Kemps Creek Warehouse, Logistics and Industrial Facilities Hub Modification 2

Amendments to Estate Roads
State Significant Development Modification Assessment
(SSD-9522-Mod-2)

April 2022

Published by the NSW Department of Planning and Environment

Figure 6 | Proposed internal road widths

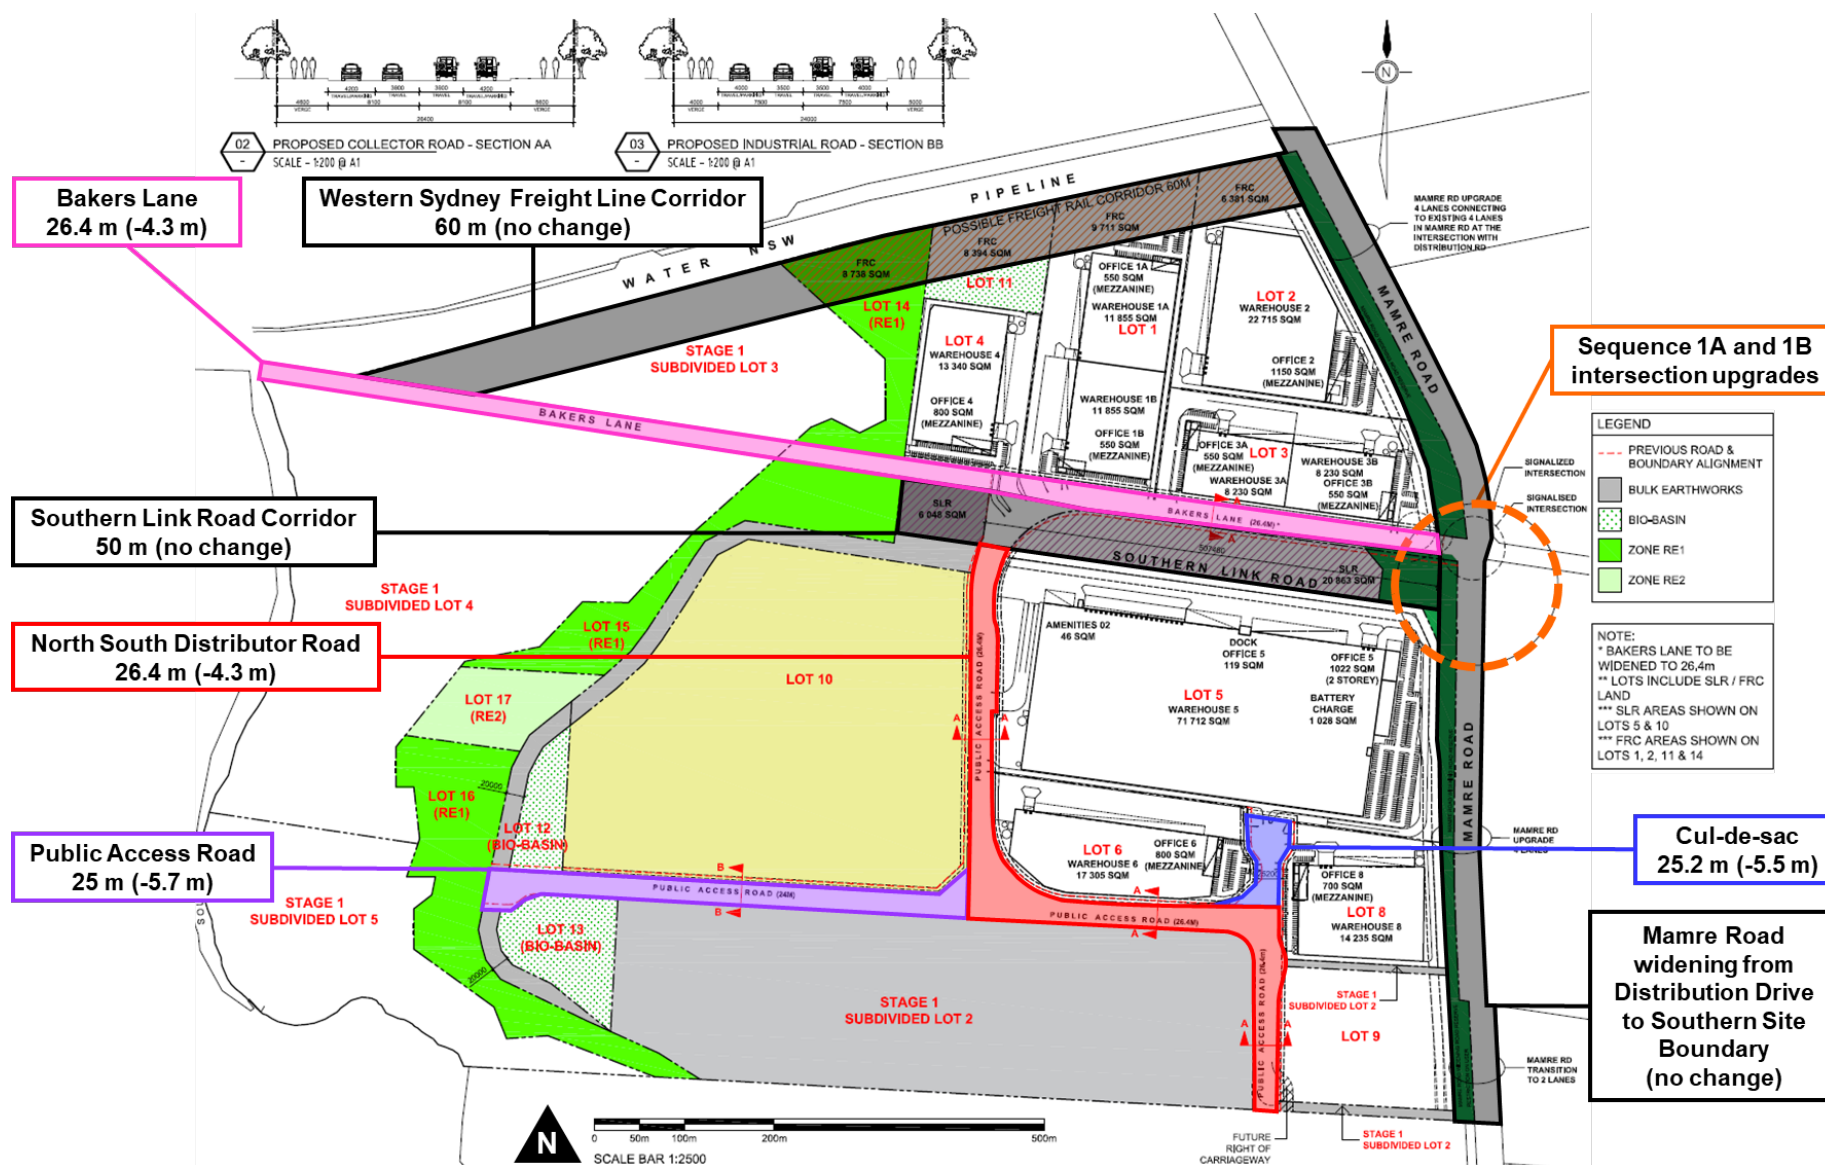
The Applicant is seeking to reduce the widths of the internal road network, including the North South Distributor Road, to increase the amount of developable industrial zoned land. These changes have the potential to impact the efficiency and safety of the North South Distributor Road.

Council advised it did not support the reduction of road widths as it would result in an increase in GFA and consequently a decrease in landscaping within the estate. Council also did not support the removal of the landscaped central medians and requested a minimum 1.2 m wide central median to be provided along Bakers Lane and the North South Distributor Road intersections. Further commentary on the impacts to landscaping is provided in **section 5.2** of this report.

The Department's Chief Engineer reviewed the information provided by the Applicant. The Chief Engineer was satisfied the drawings demonstrated the reduced road widths would still meet relevant Australian Standards.

The Department notes the North South Distributor Road would align with the road widths provided in the Mamre Road Precinct DCP. Furthermore, the Applicant has demonstrated the proposed North South Distributor Road would continue to meet relevant Australian Standards and has been designed in accordance with *Austroads Guide to Road Design*. As such, the Department's assessment concludes the proposed modifications to the internal road widths are approvable. The Department has recommended the site plan included in the consent be updated to reflect the new road widths.

Figure 8 | Proposed North South Distributor Road Cross Section

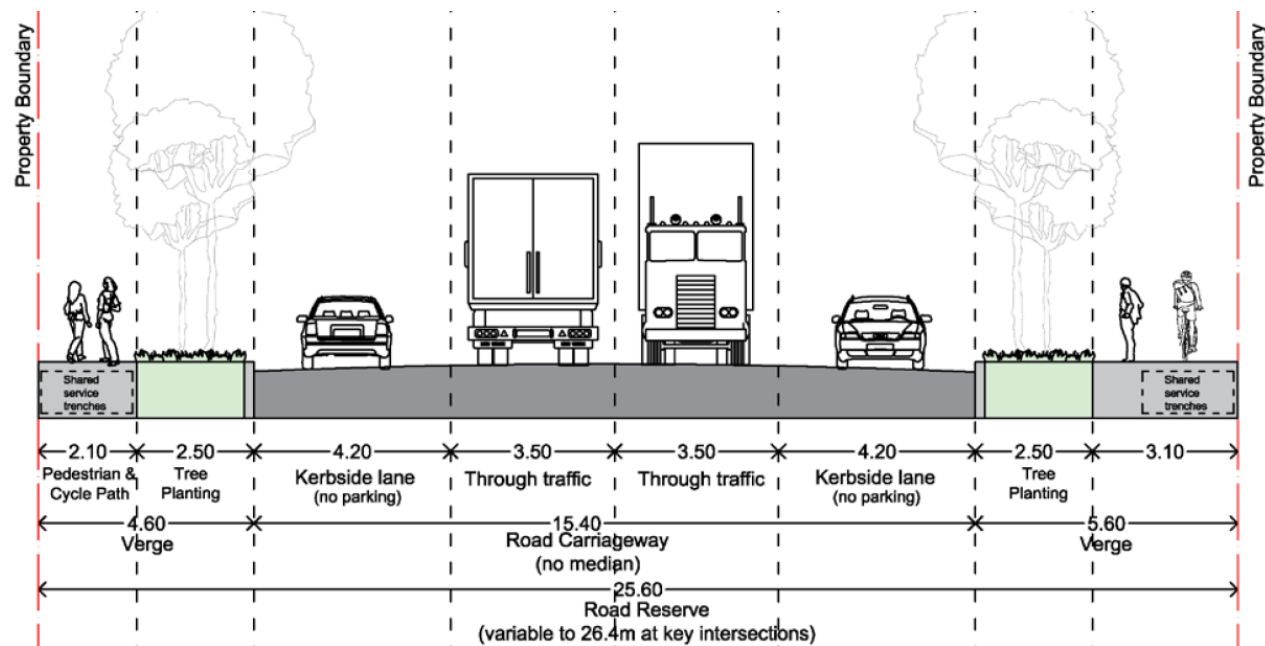
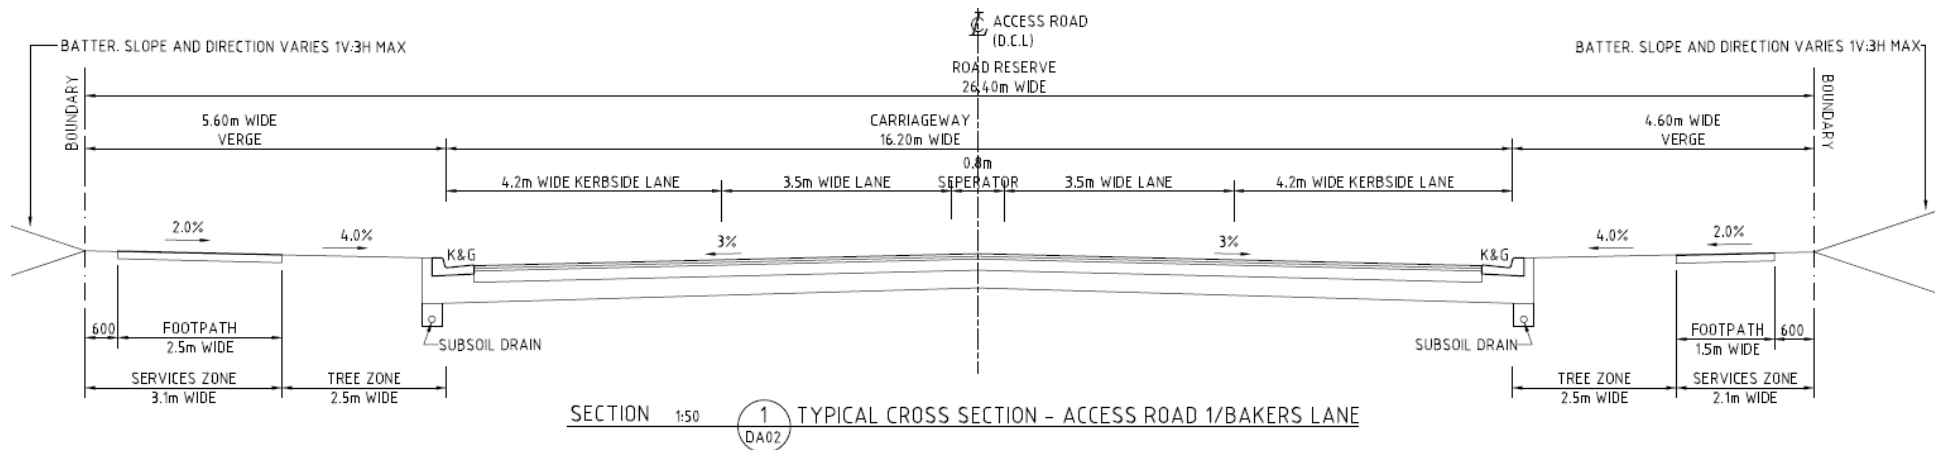
The Mamre Road Precinct DCP came into force on 19 November 2021. The North South Distributor Road is identified as a 'Collection Industrial Road' under the Mamre Road Precinct DCP road network hierarchy. A comparison of the proposed North South Distributor Road to the requirements under the Mamre Road Precinct DCP is provided in Table 2.
